APPLICATION FOR APPROVAL TO USE AN EXISTING ON-SITE WASTEWATER TREATMENT & DISPOSAL SYSTEM / WATER SUPPLY WELL

JOB LOCATION INFORMATION
TAX PARCEL #: 1133 8117
STREET ADDRESS: 11109 Mount Olive church
CITY: Charlotte
STATE: NC ZIP: 28278

IMPROVEMENT PERMIT for a RESIDENTIAL ON-SITE WASTEWATER TREATMENT & DISPOSAL SYSTEM

Residential Subsurface Wastewater Treatment and Disposal System Proposal

PROPOSED PLOT PLAN

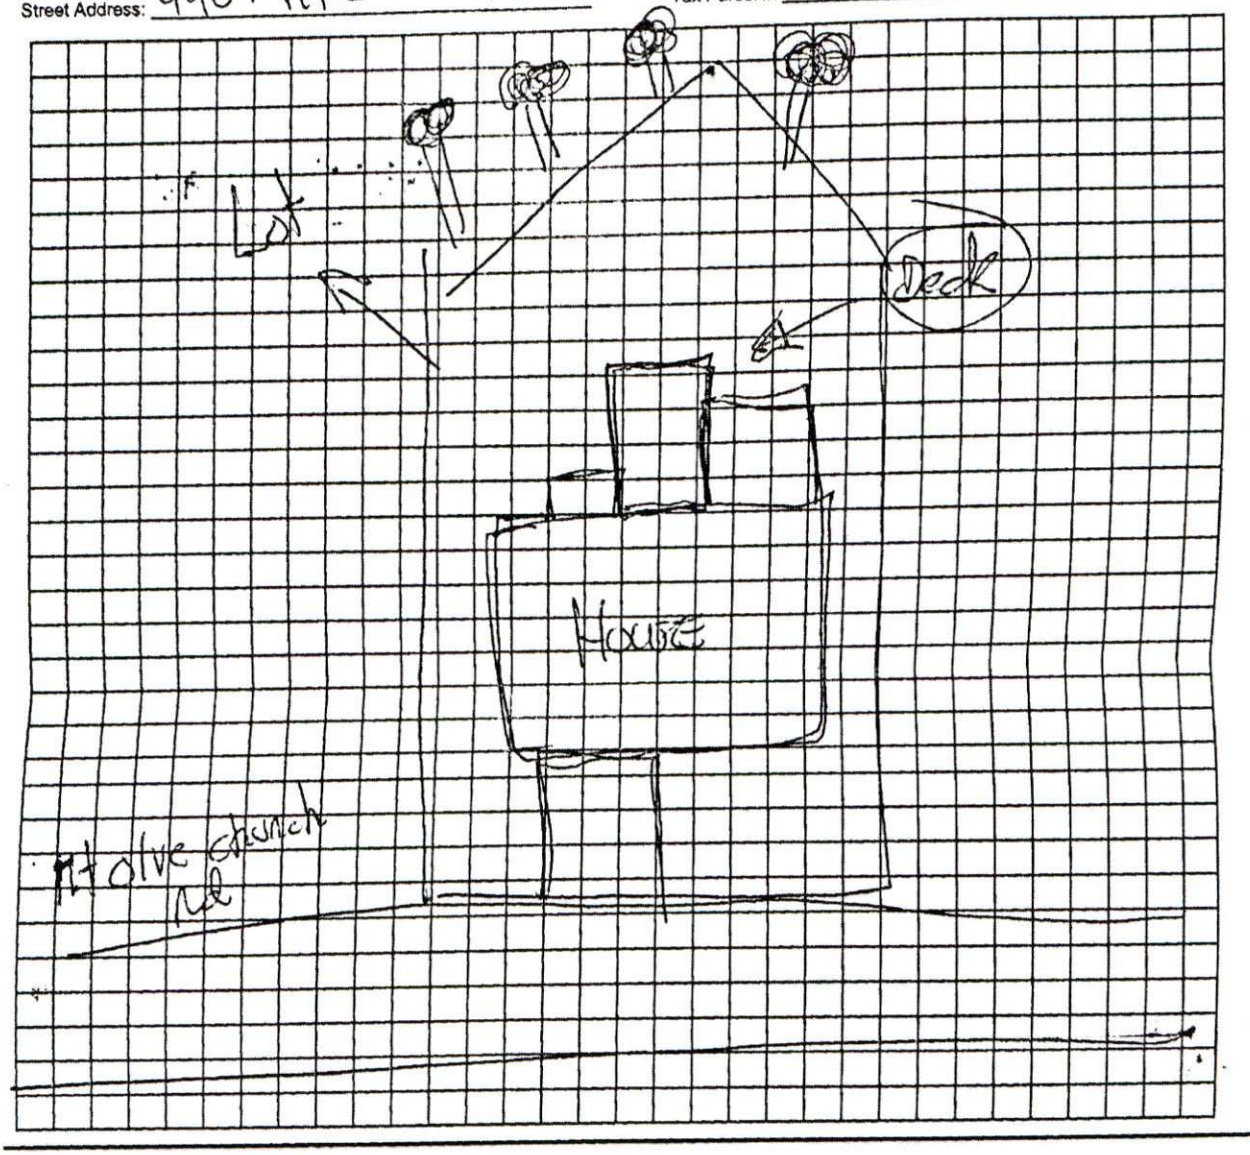
New construction meets required setbacks.

Easwe Storage building is 5ft min of system

Plot Plan SURVEY

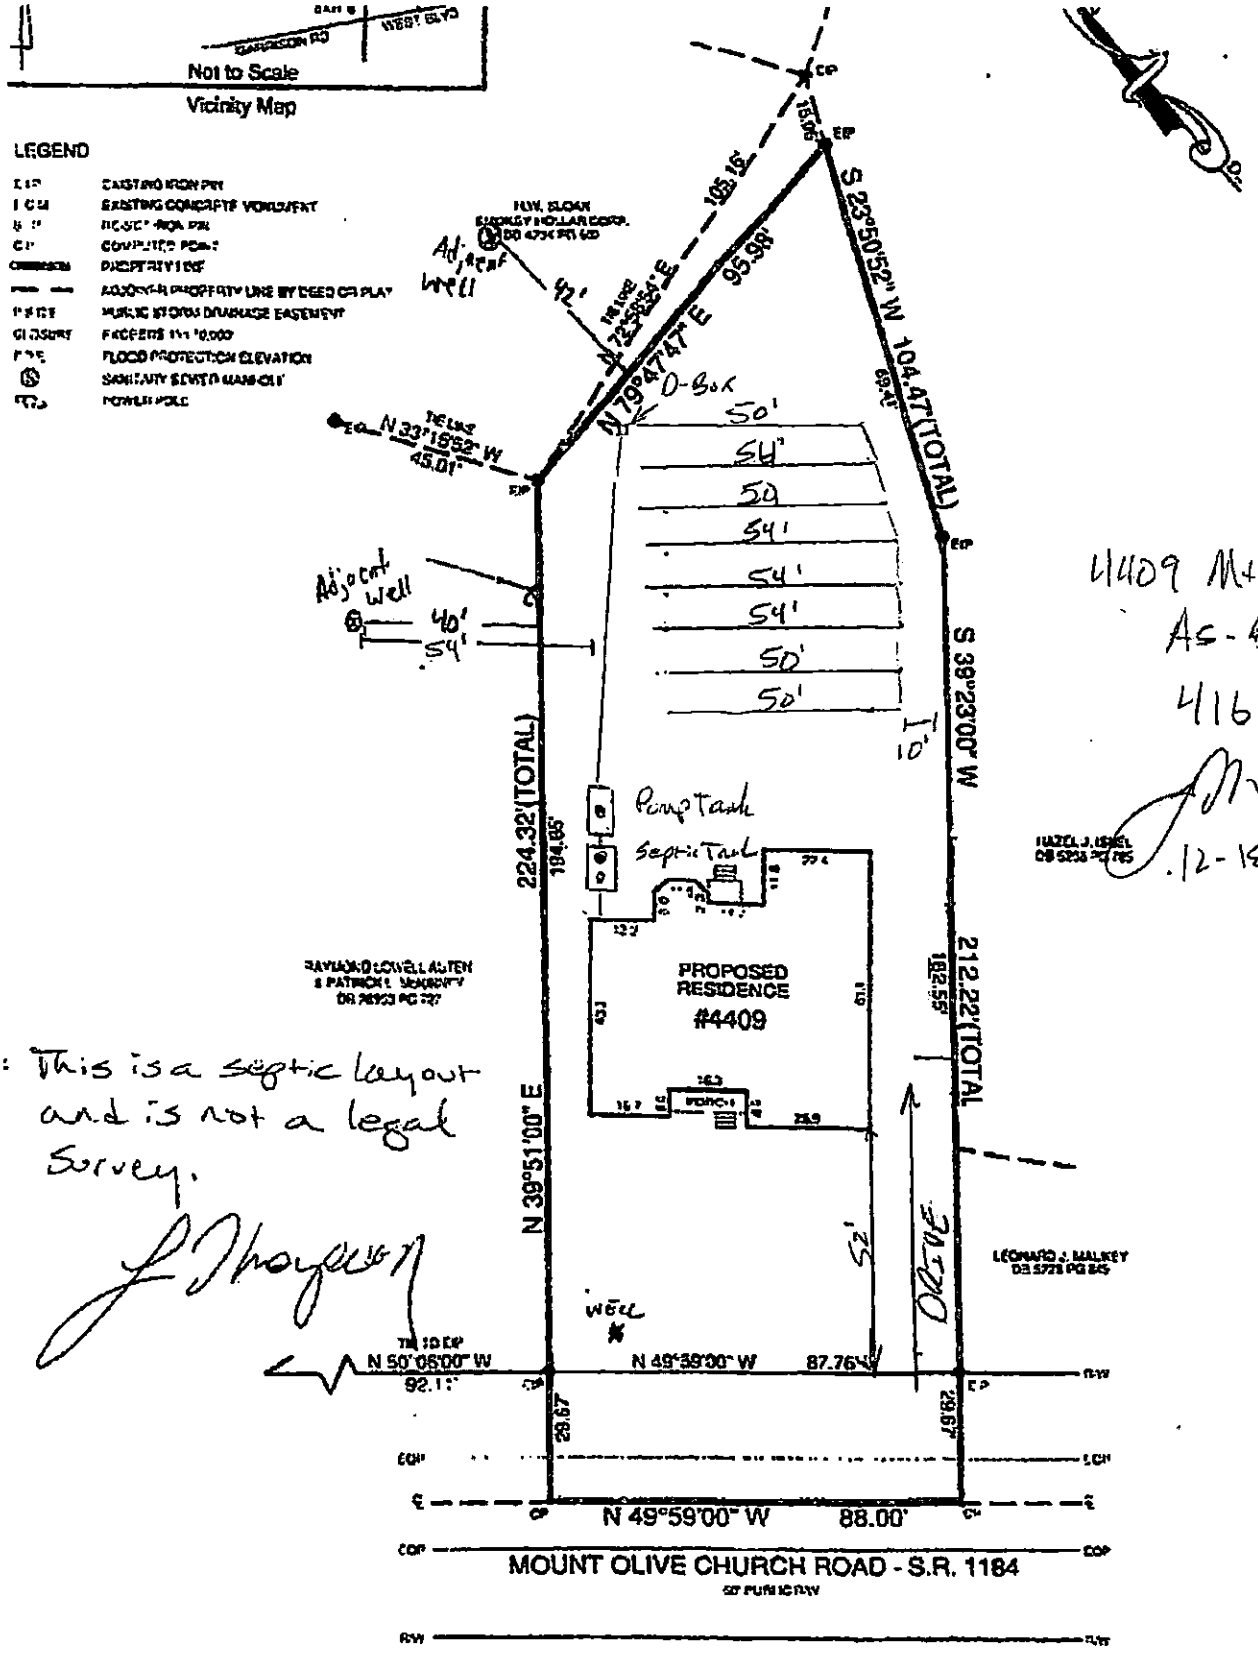
4409 Mt. Olive Road
As-Built
416 LF
